**Regarding
Performance Designs Service Bulletin # 002
Relative Workshop Service Bulletin # 230505.**

SERVICE BULLETIN

Date: 5/23/2005
Service Bulletin #: PDSBLTN-002, RWSBLTN-230505
Subject: Inspection of Tandem VTC-III reserves (VR-360) A Line Attachments and Steering Lines.
Status: MANDATORY

II. Steering Line LST Loop

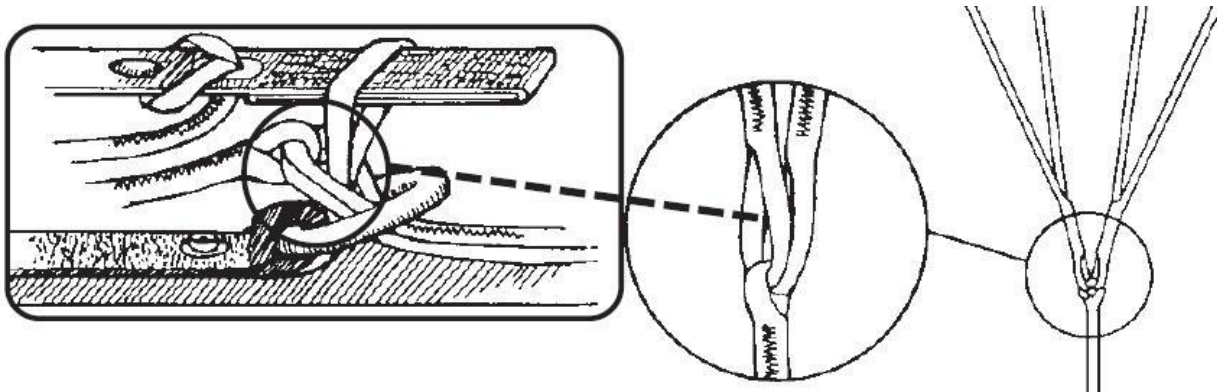
Some VR-360's were manufactured with the lower control line loop to be as large as the upper control line loop at the cascade. While there is no impact to the structural integrity, or performance of the canopy, this situation opens the possibility for the riser brake-setting loop to be misrouted through the lower control line instead of the correct location in the upper control line as shown below. Improperly set brakes can result in brake line failure during opening and unusually high opening forces.

1. Inspect the LST attachment loop per the attached Inspection Procedures Section 2, LST Loop Inspection.
2. If either steering line does not comply with the proper configuration of the loop, the parachute must be brought into compliance by a certificated rigger following the provided instructions prior to placing back in service.

Figure 1 Rib leading Edge Tape Inspection

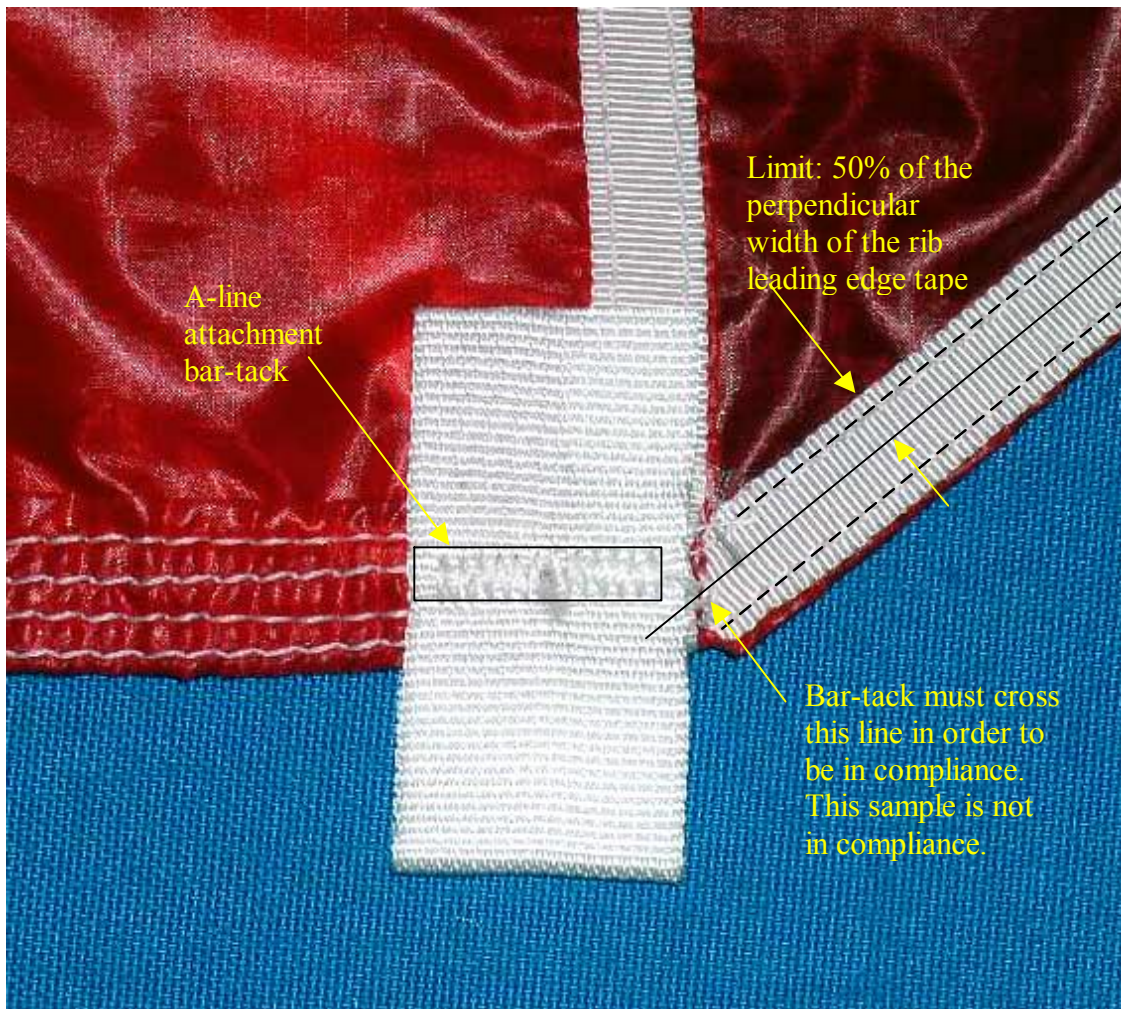
1.1 Rib Leading Edge Tape Inspection Criteria

The A-line attachment bar-tack must be sewn through at least 50% of the width of the loaded-rib leading edge tape.

- a) Using a ruler, find the centerline of the rib-leading edge tape. This may be lightly marked with pencil if necessary.
- b) Using the ruler, extend the centerline of the leading edge tape to the vicinity of the bar-tack.
- c) Observe the location of the bar-tack with respect to the tape centerline.

1. Inspect all ten of the A-line attachments per the attached Inspection Procedures, Section 1, A-line Attachment Inspection Procedure.
2. If any of the 10 A-line tab bartacks do not comply with the proper alignment the parachute must be brought into compliance by an approved service facility. Adjusting the line tab requires a specialized heavy-duty bartacker not commonly found in the field.

Figure 2- Bottom Skin LE Tape Inspection

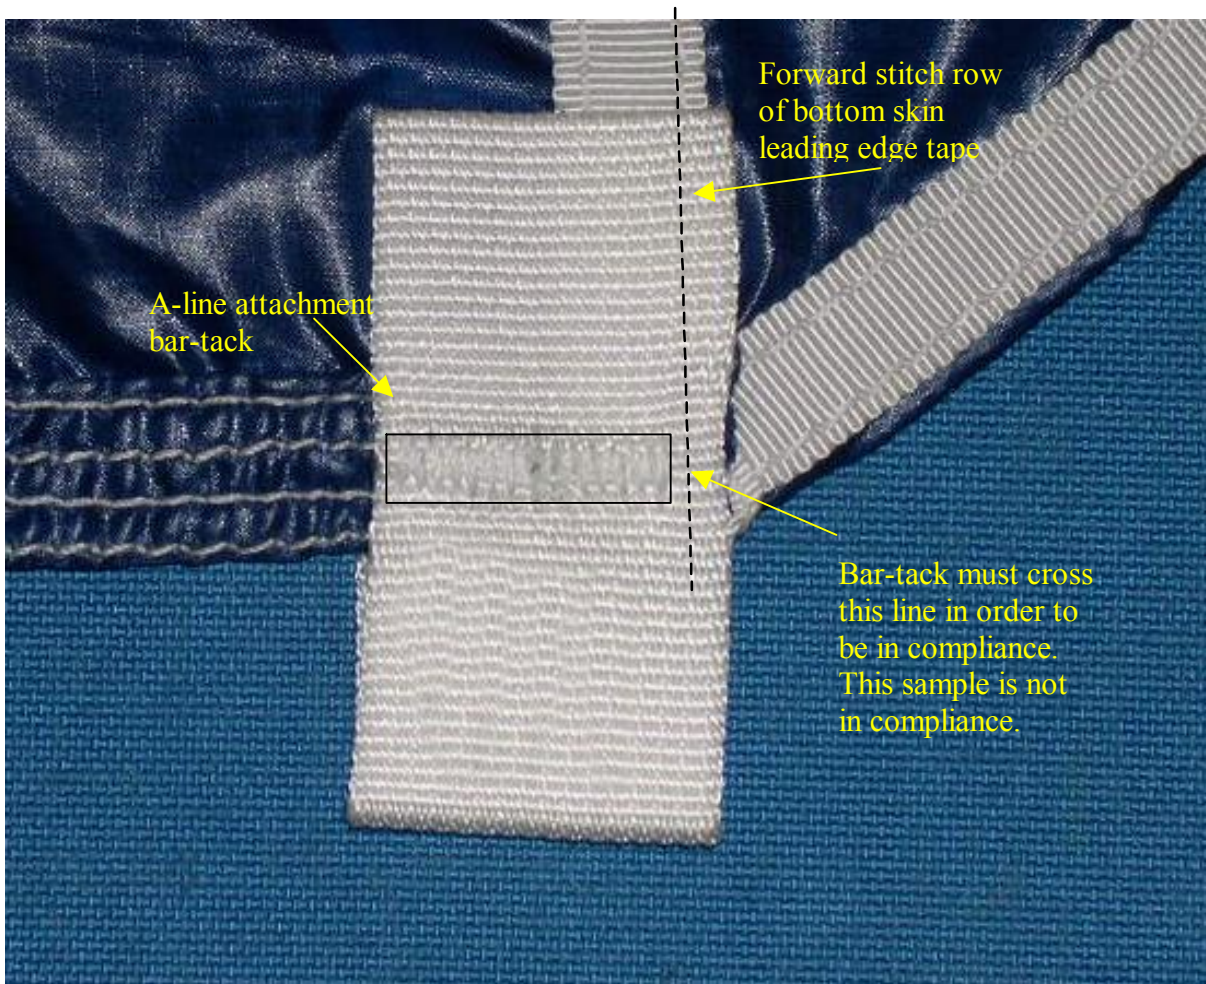
1.2 Bottom Skin Leading Edge Tape Inspection Criteria

The A-line attachment bar-tack stitching must extend forward of the forward stitch line on all the bottom skin leading edge tapes. Inspect both sides of tab.

- Locate the forward stitch row of the bottom-skin leading edge tape.
- Using a straight edge, extend the forward stitch line of the leading edge tape to the vicinity of the bar-tack.
- Observe the location of the bar-tack with respect to the tape stitch row. The bar-tack may or may not overlap the edge of the line-tab, but it must cross the stitch-row and be going through the tab at this point.

Figure 5 Good LST Loop

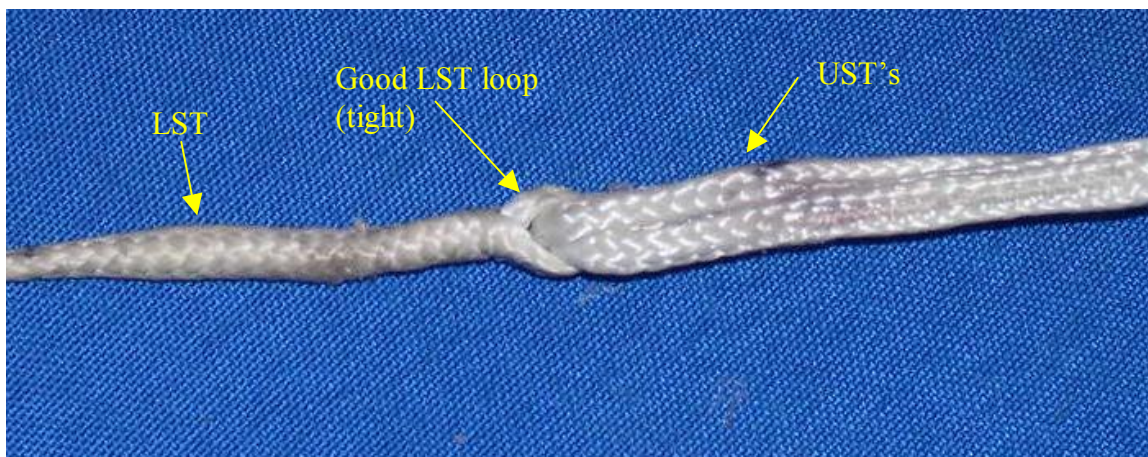
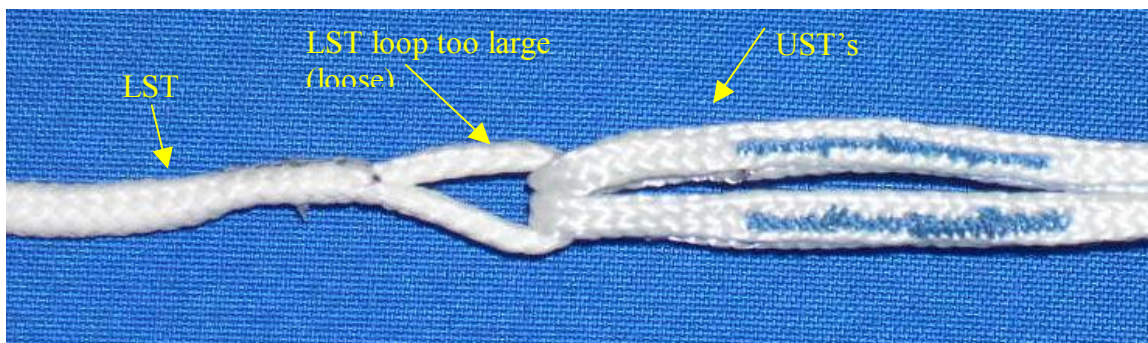
Check each of the LST's (lower steering lines, the line that passes through the toggles) where it loops around the UST (upper steering line). This loop must be small enough that the brake setting loop on the risers cannot be pulled through.

Using Figures 7 and 8, evaluate the LST loops.

The LST loop may be reduced to an acceptable level by adding a bar-tack or zigzag stitch to reduce the open legs of the loop. The following includes directions for reducing the existing LST loop.

Figure 7 Top View, LST Loop Adjustment

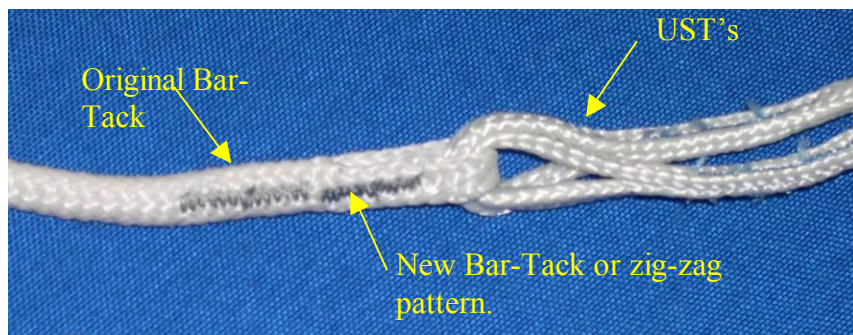
The stitch shall be installed to the legs of the LST loop between the existing bar-tack and the loop around the UST lines as shown in Figure 9. The UST's may be left in place while this work is done, given sufficient care to avoid stitching thru the UST material.

The work must be performed by a certificated rigger. The stitching must be Nylon E-thread. Stitching may be done with a single throw zigzag, double throw zig-zag, or a bartacker with between 28 and 42 stitch conventional or center start pattern. Stitch pattern should be between 1/2" and 5/8" long, and 1/8" wide. For zigzag stitching, the preferred pattern is to start at or near the existing bartack, sew toward the UST, and then reverse back to the starting point. Zigzag stitching shall be 12 to 16 stitches per inch for single throw, and 8 to 12 stitches per inch for double throw.

Figure 8 Side View, LST Loop Repair.

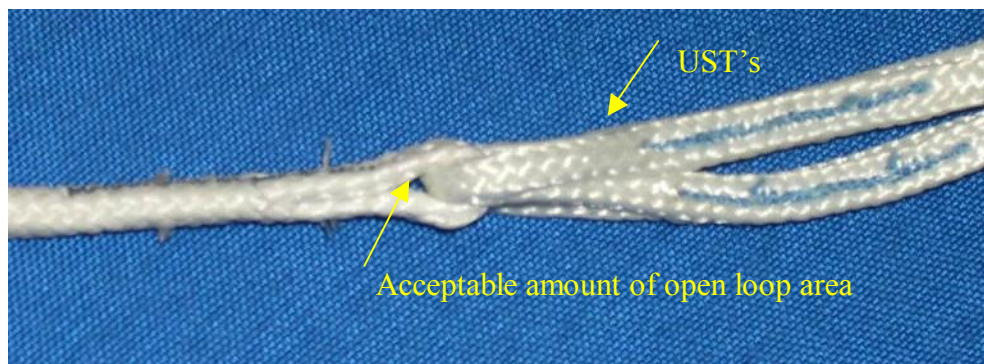
The stitching shall not overlap the existing bar-tack or penetrate the UST material passing through the loop. See Figure 10. A small amount of open area within the loop is permissible after the repair.
